# ADDENDUM NUMBER 2

Issued January 9, 2020

Project ENG16-0021  
8<sup>th</sup> Street Underpass Drainage Improvement Project

**8TH ST. UNDERP.**  
100% DESIGN PLANS  
SHEET NO. **E10**  
10 OF 12

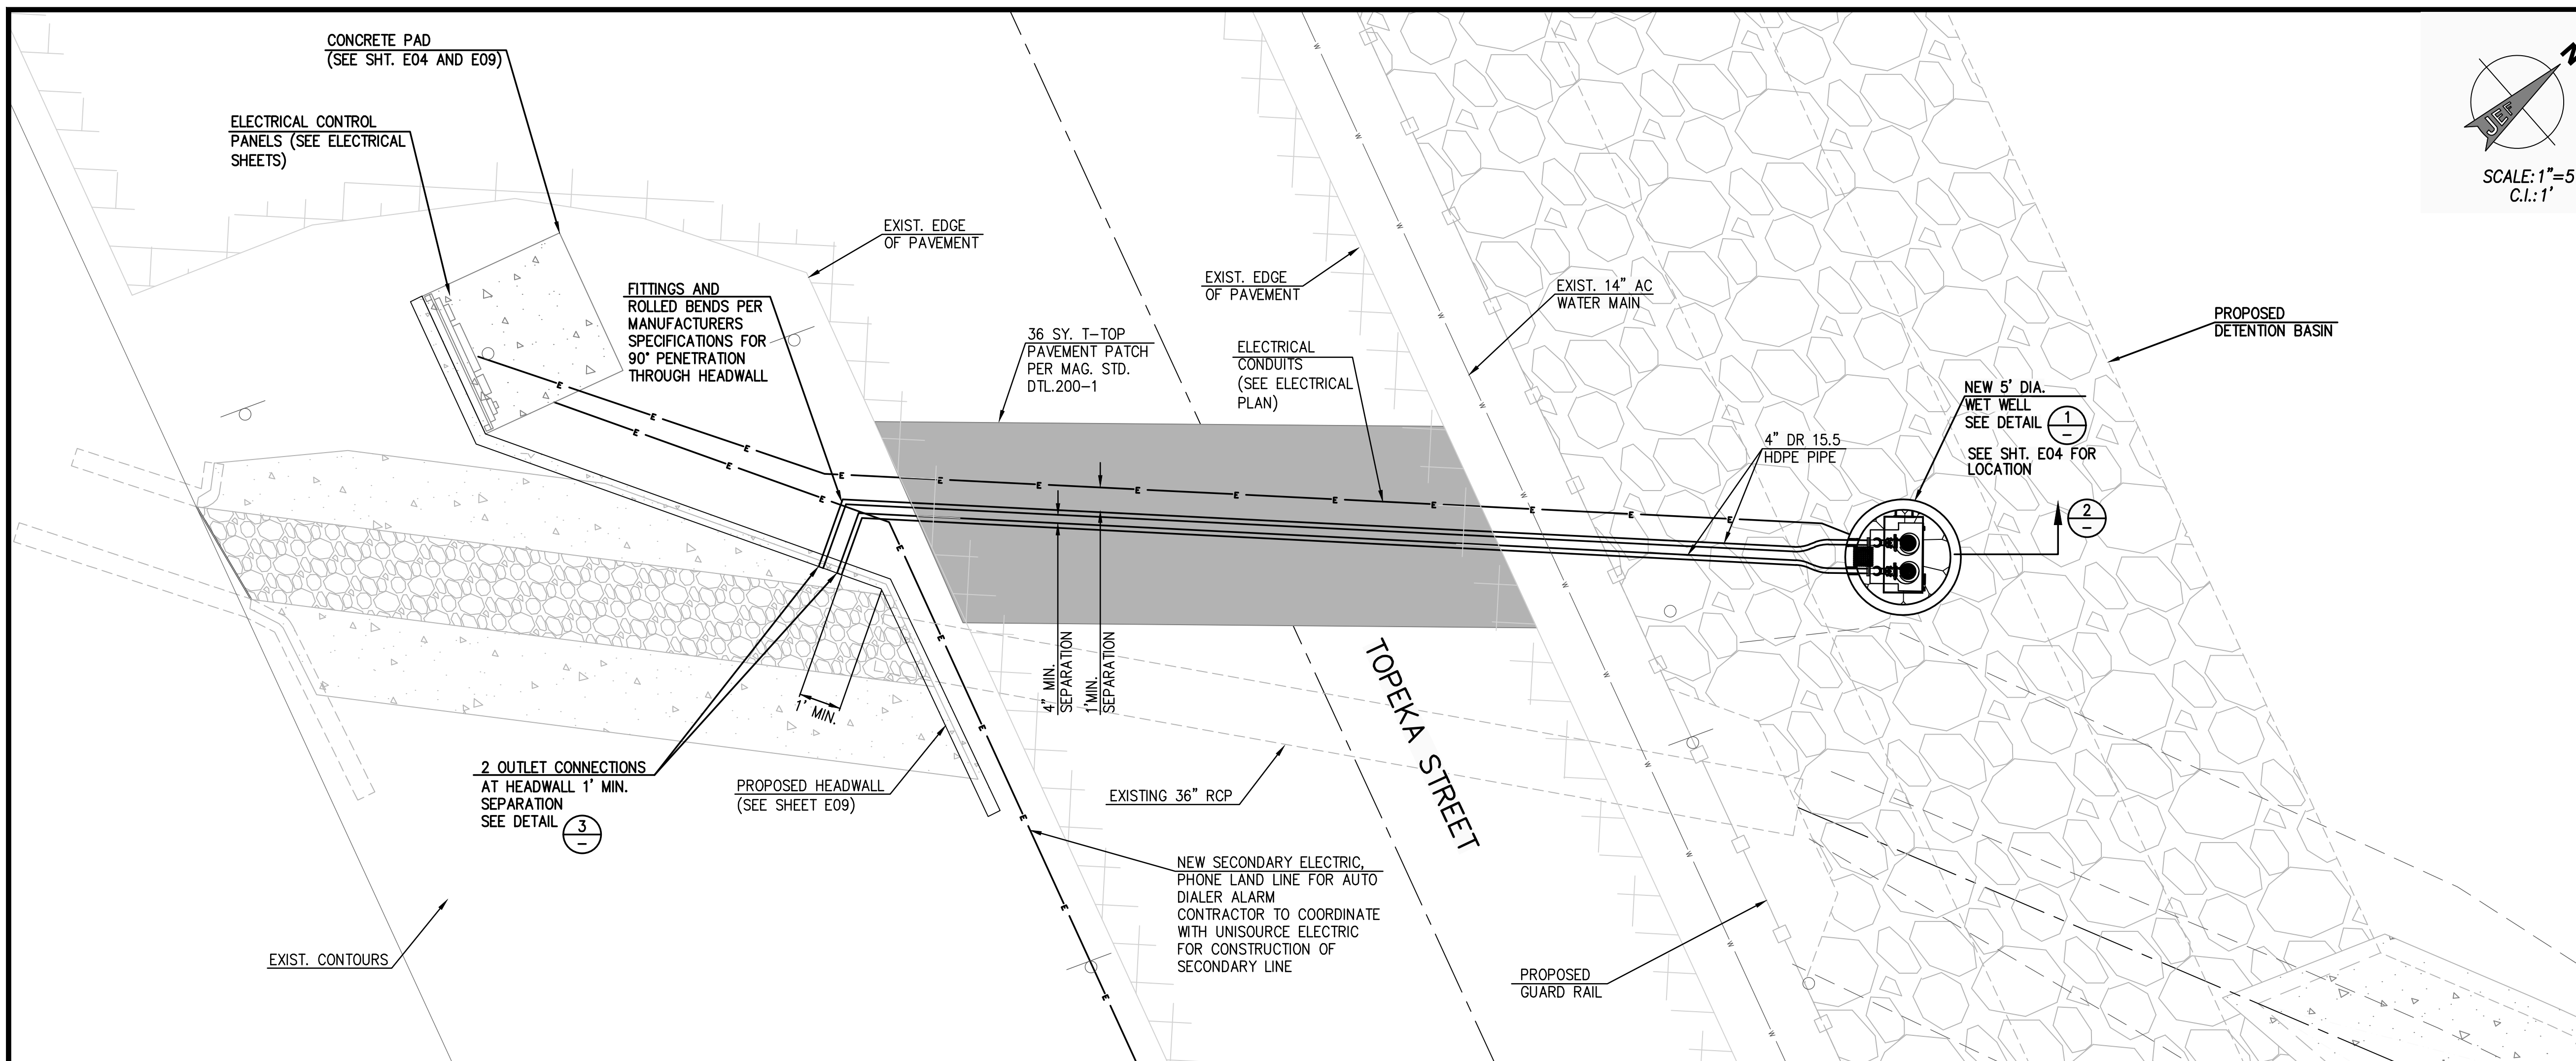
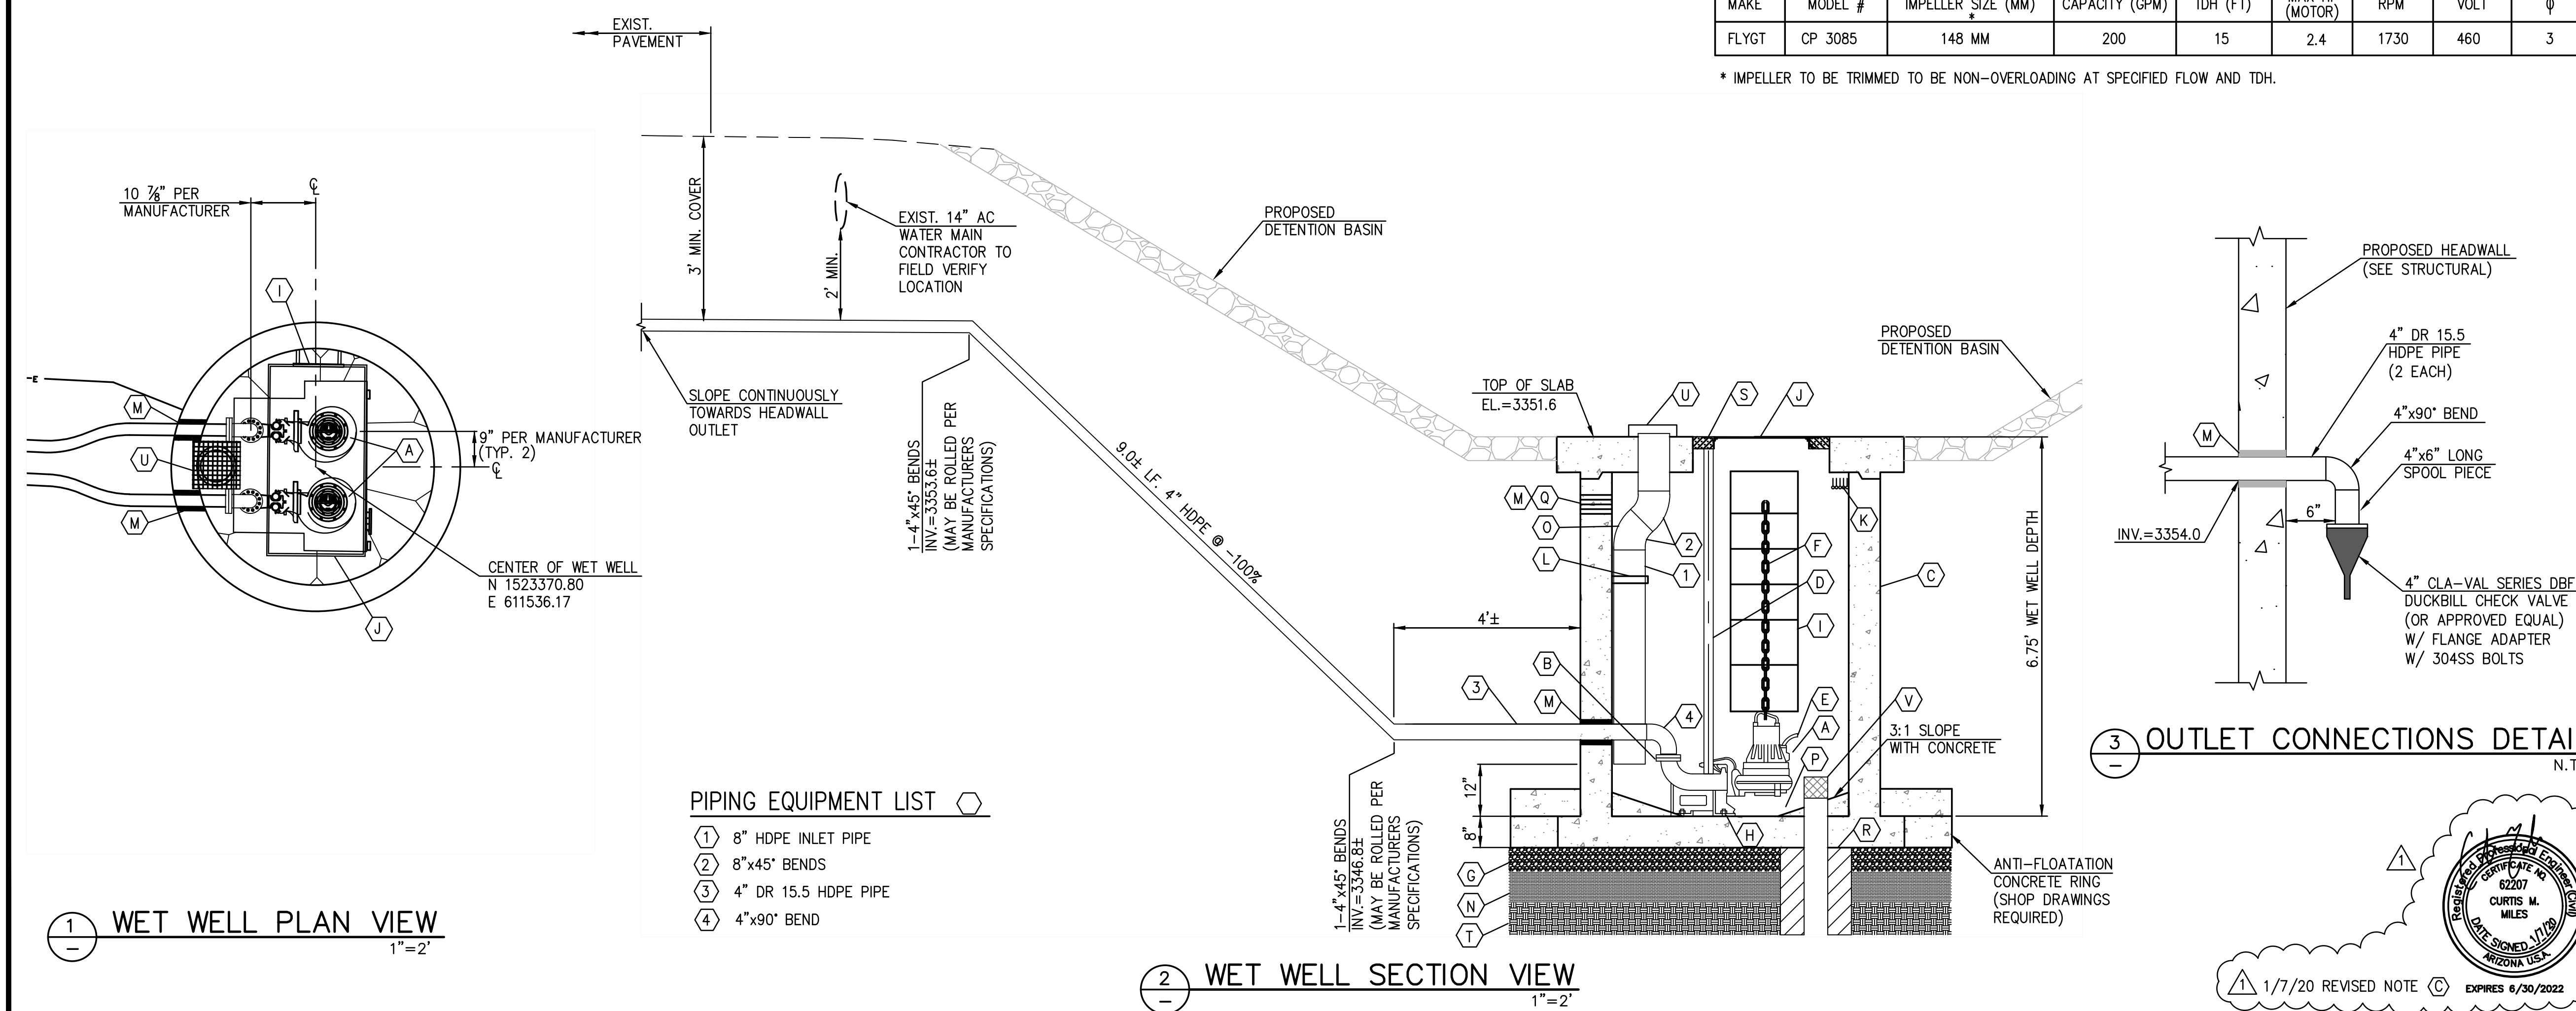
This addendum includes a revised SPECIFICATION FOR WET WELL CONSTRUCTION- (NOTE C, SHEET E10). 10,000 PSI MIN. PER ASTM-D 6783 COMPRESSIVE STRENGTH IS DELETED AND REPLACED WITH **CONSTRUCTION PER MAG SECTION 742 WITH A MIN. OF 4000 PSI COMPRESSIVE STRENGTH.**

- (B) 4" DISCHARGE CONNECTION AND 4" ELBOW.
- (C) WET WELL - SHALL BE PRECAST STRUCTURE PER MAG UNIFORM STANDARD SECTION 742 UNLESS OTHERWISE NOTED. CONSTRUCTION SHALL BE CONCRETE WITH A MIN. OF 4,000 PSI COMPRESSIVE STRENGTH AT 28 DAYS. CONCRETE SHALL CONFORM TO ASTM C-478 AND AASHTO M-199. SEE MANUFACTURER NOTES BELOW

1/7/20 REVISED NOTE C EXPRES 6/30/2022
